Private Fuel Storage, L.L.C.

June 2, 2000

COMMITMENT RESOLUTION LETTER #34
DOCKET NO. 72-22 / TAC NO. L22462
PRIVATE FUEL STORAGE FACILITY
PRIVATE FUEL STORAGE L.L.C.

A meeting was held on May 25, 2000 in San Antonio, Texas between Private Fuel Storage (PFS), Stone and Webster (S&W), and the NRC/CNWRA to discuss several open issues remaining with the Private Fuel Storage Facility (PFSF) Safety Analysis Report (SAR). The topics discussed and the PFS actions necessary to resolve these issues are outlined below.

NEW SPECTRA

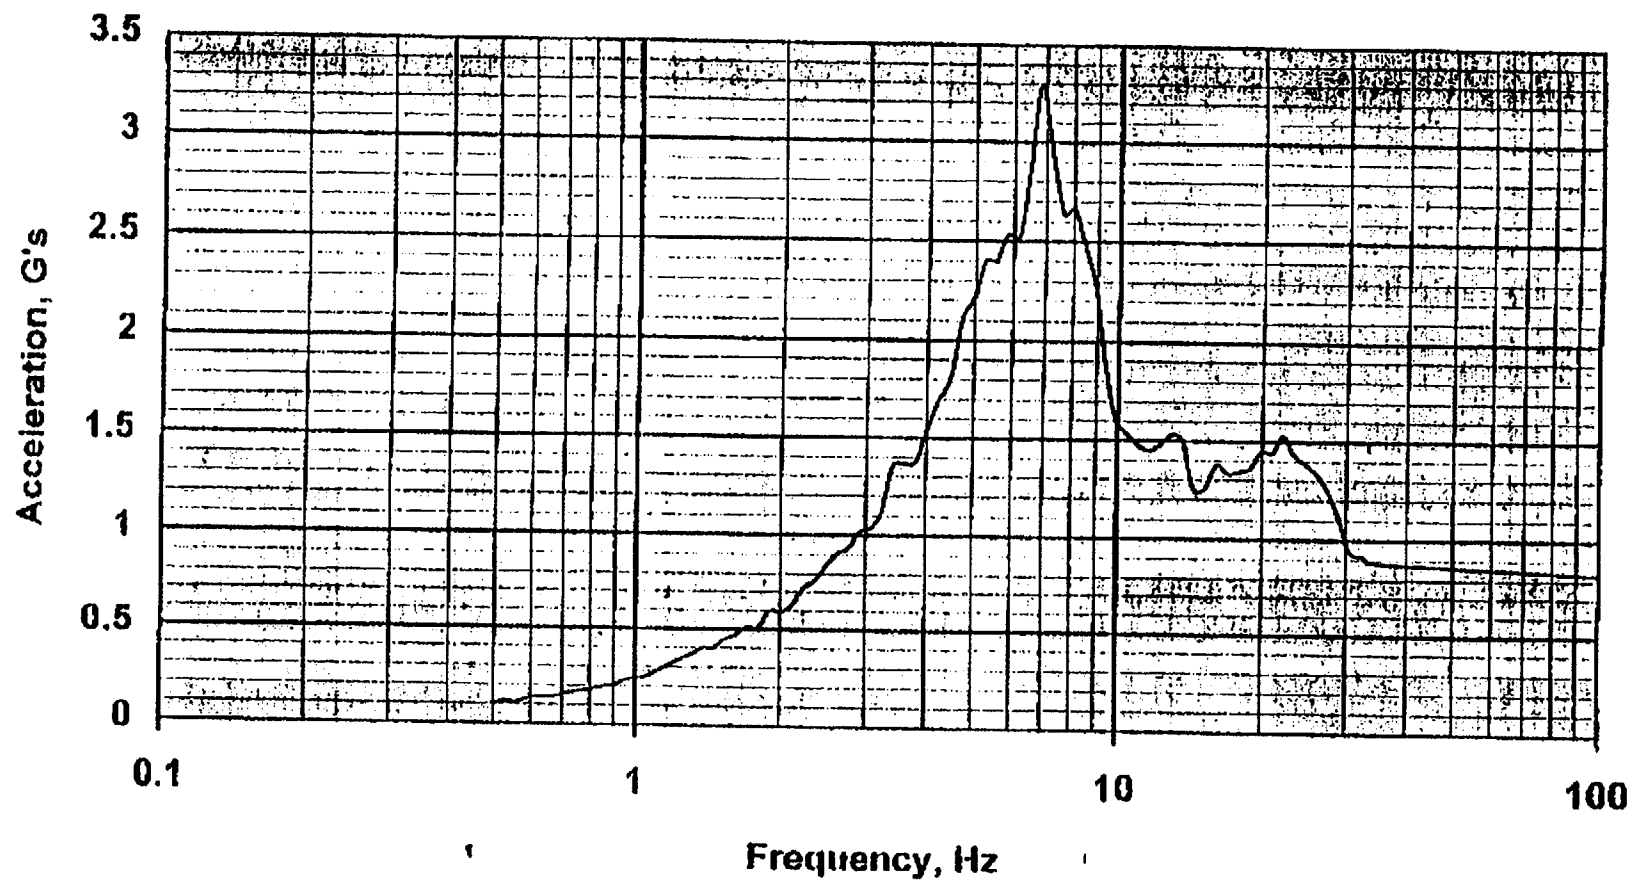
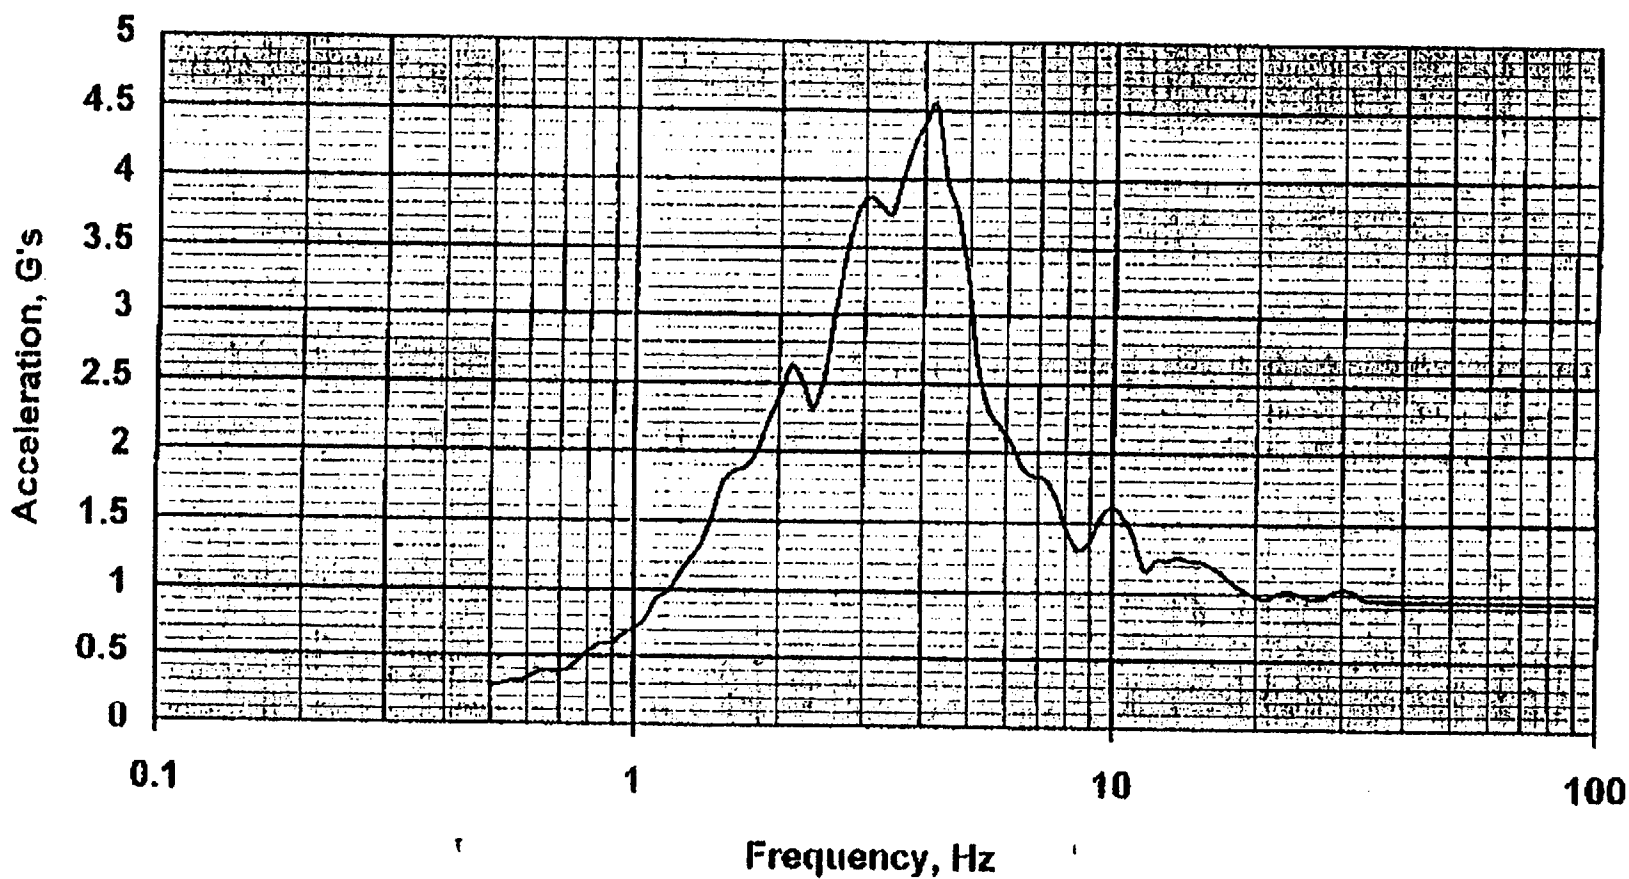
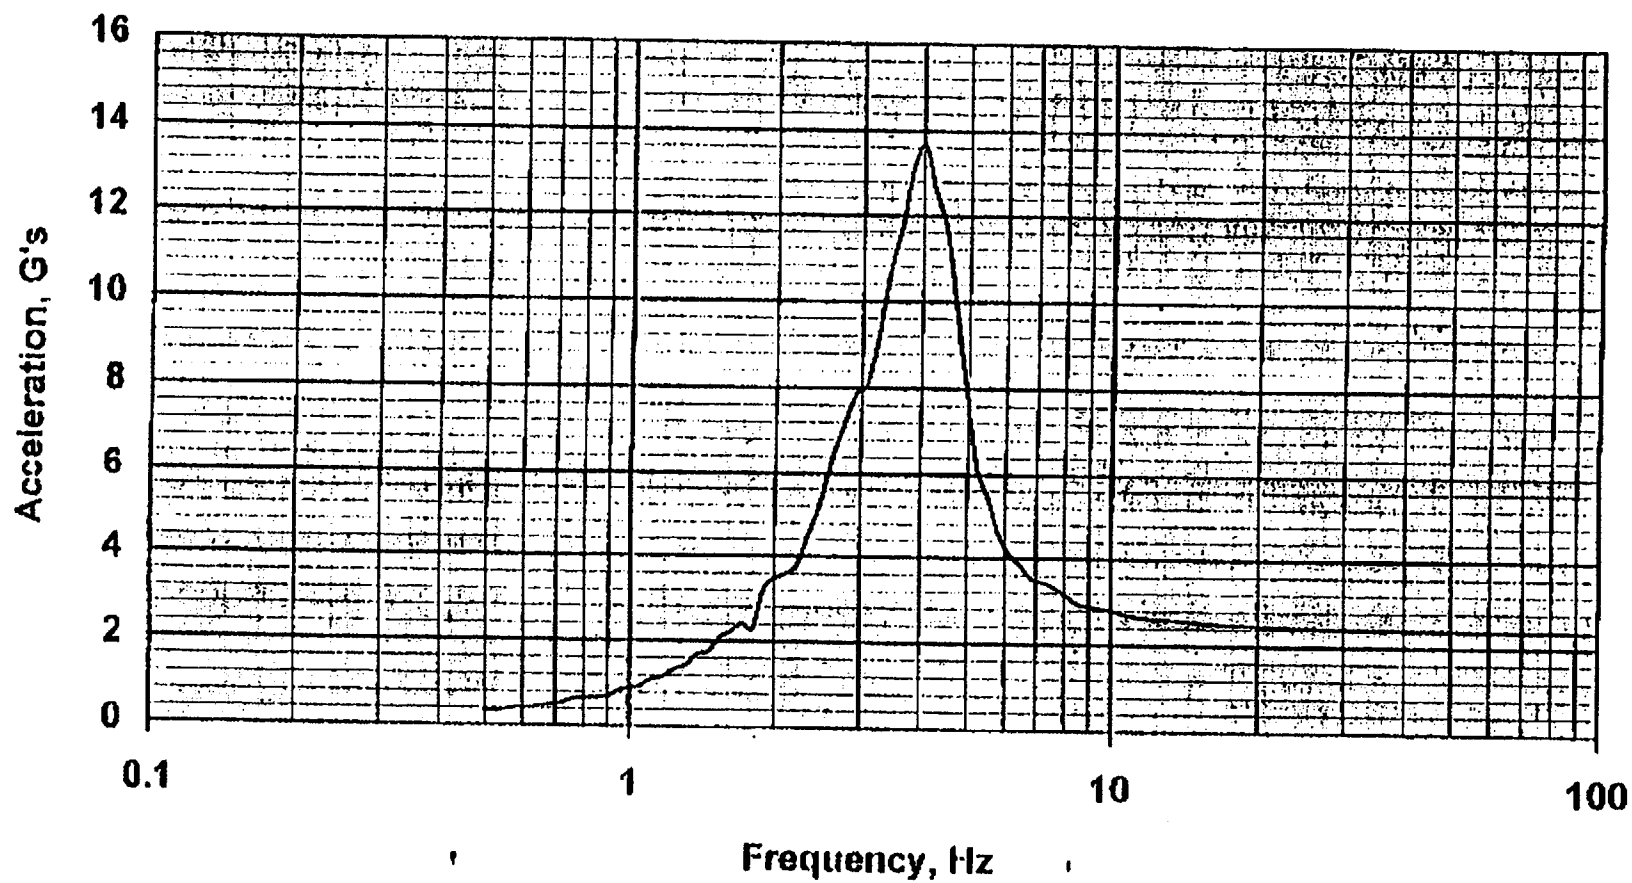
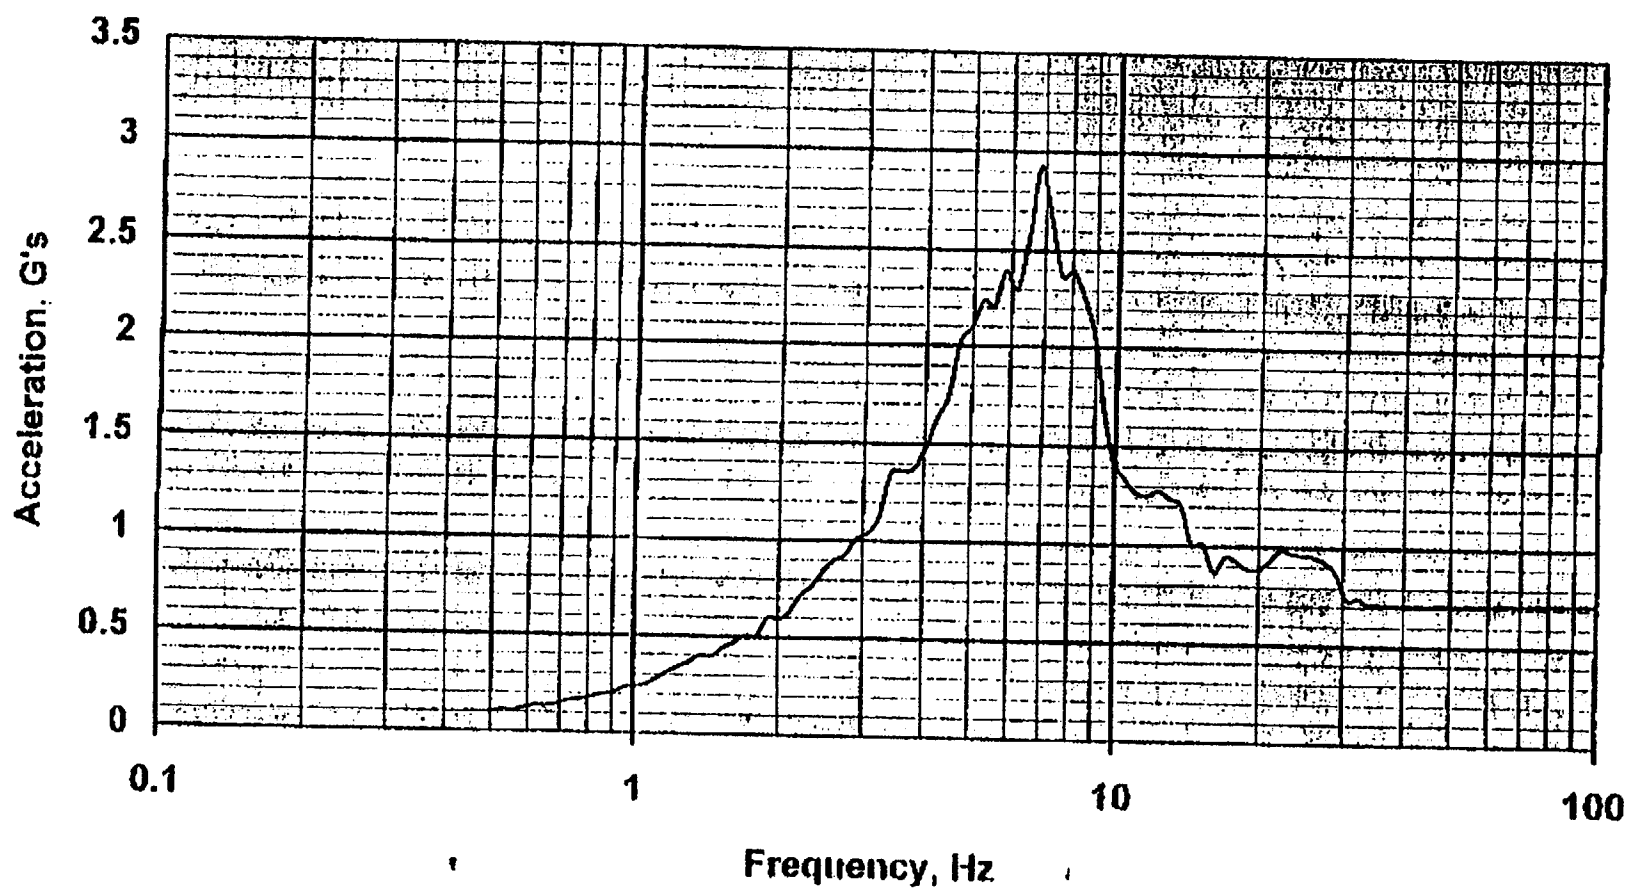
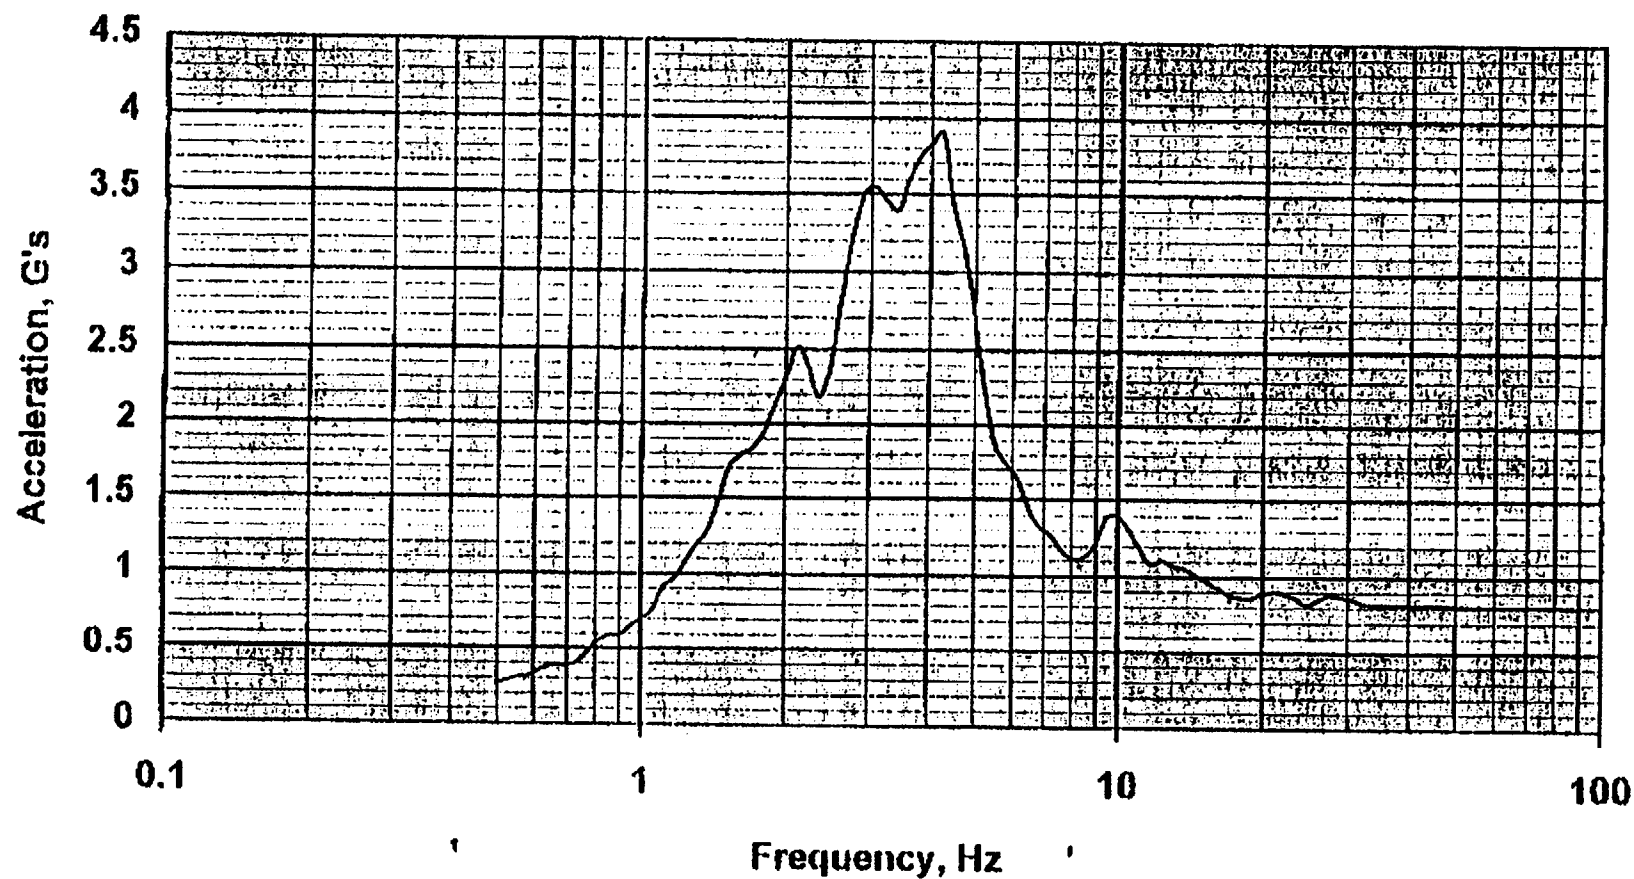
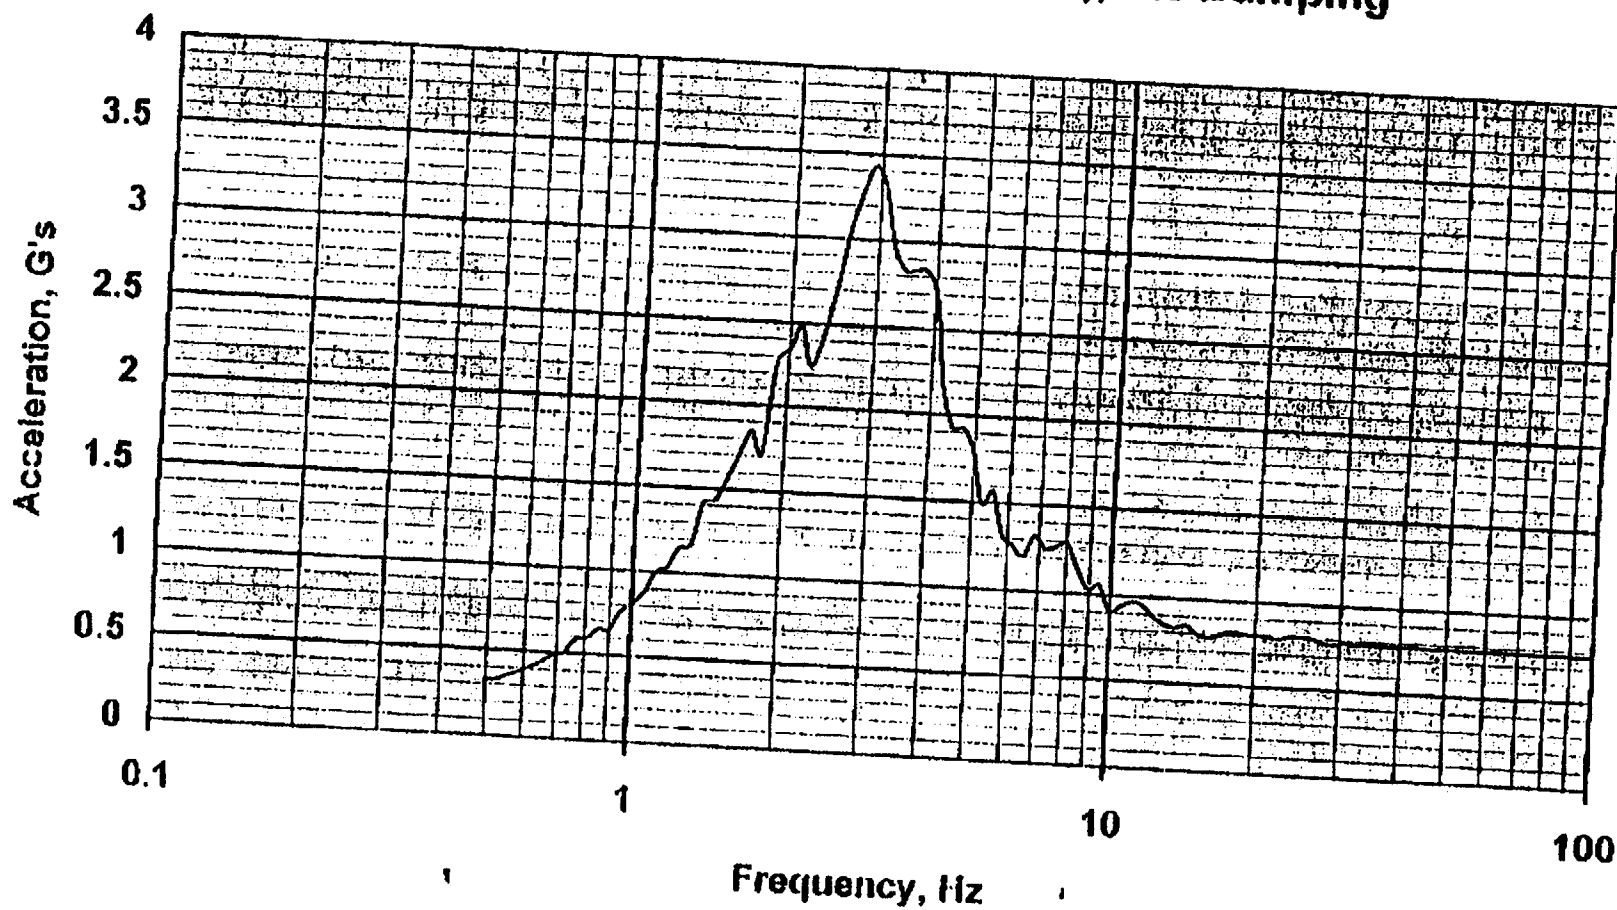
1. The seismic ground accelerations in the new probabilistic design basis are lower, however the dynamic soil properties resulted in increased accelerations at the crane rail elevations in the building. PFS needs to provide additional information on the

evaluations that were performed to demonstrate that stresses are within allowable limits and design safety factors are appropriate.

The PFSF overhead and semi-gantry cranes have been seismically analyzed in accordance with ASME NOG-1 to ensure they will remain in place and support the load during and after a seismic event. The analyses were performed for both cranes by the crane vendor, Ederer Incorporated, to qualify the crane designs for the PFSF deterministic design earthquake (0.67g horizontal, 0.69g vertical). The cranes were subsequently reviewed by Ederer for their seismic stability based on the current PFSF probabilistic design basis ground motion of 0.53g horizontal and 0.53g vertical and resulting response spectra curves. The Ederer evaluation is summarized in SAR Chapter 4, Section 4.7.2.5.3. A copy of the Ederer evaluation (SAR Reference 63) is included as Attachment 1 and should provide the additional information requested.

The Phase I, Initial Detailed Engineering for Ederer Job Nos. F2621 (200T Bridge Crane) and F2622 (150T Semi Gantry Crane) was carried out using the response spectra curves per the original specification attachment 9, and are included in Appendix A. Revised curves are dated 8/30/99 and are also included in Appendix A. Table 1 gives a comparison between the original and revised curves on the basis of peak acceleration, frequency and percent increase (or decrease) in peak acceleration. Tables 2 and 3 list the maximum percentages of allowable stress for the various components analyzed in the seismic analysis that was originally done on these cranes. Since the peak accelerations occur at relatively low frequencies ($\approx 3-4$ hz horizontal, and $\approx 6-7$ hz vertical) and, these frequencies are close to typical crane structural natural frequencies, a dynamic analysis would have to be done to really define how the structural loading might vary. This would be especially true if a particular mode were close to either the increasing or decreasing side of the response curve. Comparison of the static peak accelerations will however, give an indication of the results of a dynamic analysis.

For the 200T bridge crane, the vertical peak change is +14%. The N-S lateral forces are governed by wheel slip and will remain constant. Since the bridge girders, trolley trucks, trolley girder and equalizing sill are at approximately 90% or more of the allowable stress and this margin should be maintained, the section moduli would have to increase approximately 14%. The bridge trucks will be also affected by the large E-W horizontal peak change (+100%). They are however at a lower % allowable stress of $\approx 72\%$. The section modulus for the trucks would then have to increase approximately 10%. See Appendix A for a sample calculation. Our conclusion is that the bridge crane will still fit in the same envelope as shown on PA-2189, Rev. B but will be somewhat heavier.

For the 150T gantry crane the vertical peak change is +14% on the west end and +8% on the east end. The N-S lateral forces are governed by wheel slip and will remain constant. The E-W lateral peak change is +100% on the west end and -17% on the east end. The equalizing sill, end tie, and gantry trusses are at low enough % allowable stress that they should remain unchanged. The bridge girder, trolley truck and trolley girder section moduli would increase by approximately 12%. The gantry leg section modulus would increase approximately 50% at the top end and remain the same at the bottom. The joints at the girder/leg interface and the girder/truck interface would have to increase in strength to handle the increased E-W lateral loading. The bridge trucks will be affected by the vertical peak change and the large E-W horizontal peak change at elevation 170 ft. They are however at a % allowable stress of $\approx 75\%$, similar to the bridge crane. The section modulus for the trucks would then have to increase approximately 10%. See Appendix A for a similar sample calculation. In conclusion, we expect that the semi gantry crane will still fit in the same envelope as shown on PA-2190, Rev. C but will be somewhat heavier.
